Comments on proposed development, Parcel #4022900497

File 2021-RUE-0001

RE: Arborist Report- Mark Garey property NE 205 Street and 37th Avenue NE, P#4022900497

Photo 2

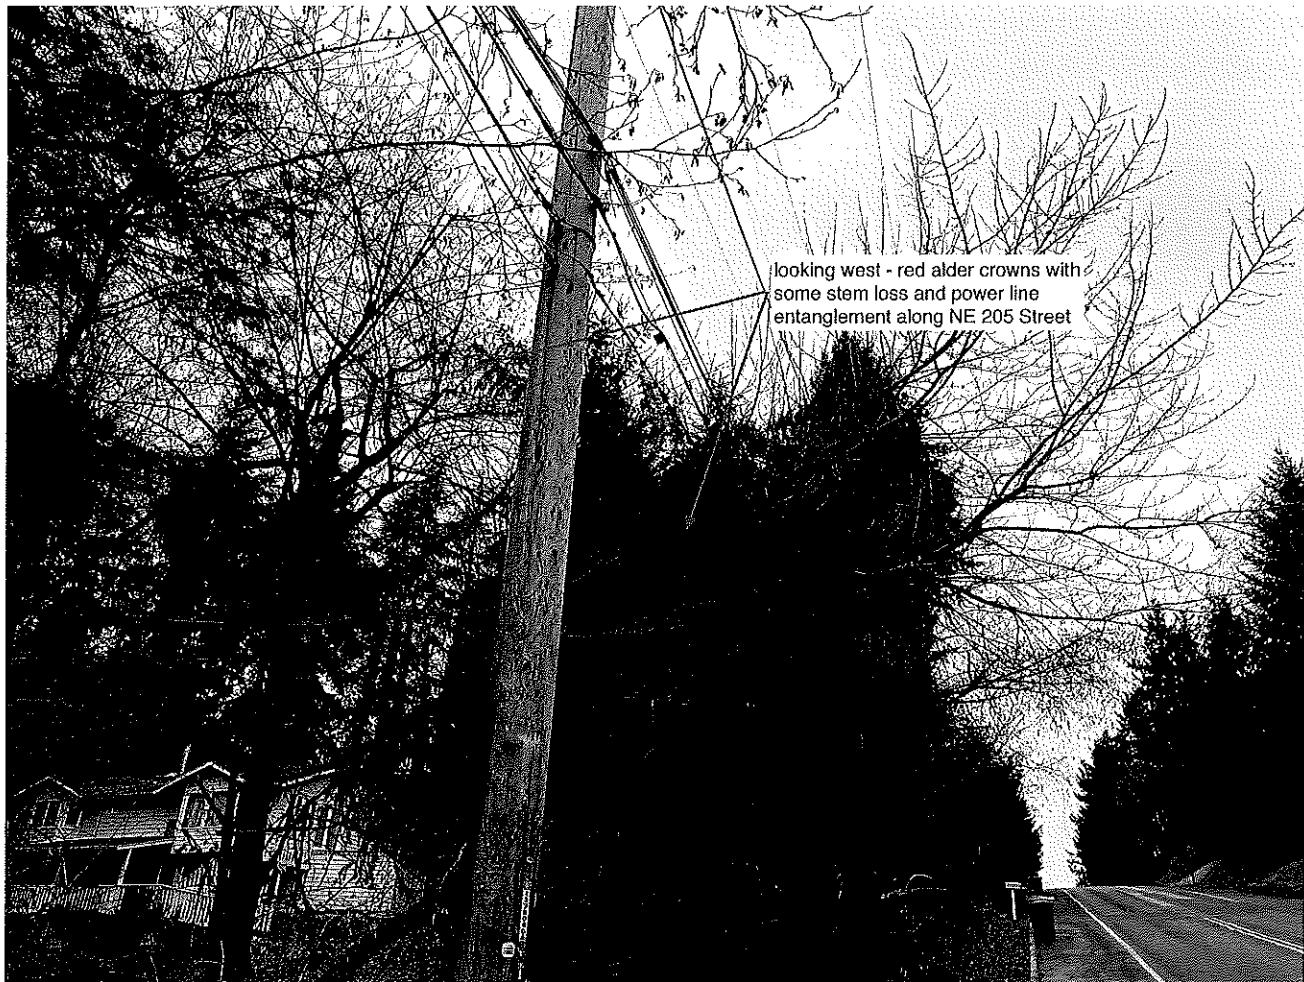
There are several trees on the widened arc of the Public Right of Way including Douglas firs, Sitka spruce and red alders (**see photo 2**). The root zones of these trees forming a grouping would likely be impacted adversely by the clearing limits for water services as identified in Proposed Impacts Assessment W2 of 6. The Report mentions that development proposals shall place a strong emphasis on tree protection LFPMC 16.14.070D as *Tree retention plans shall prioritize i. Existing viable trees in groups or stands.* No mention was given in the Report about what recommendations would be made for these four trees in the Critical Areas Zone of the Public Right of Way.
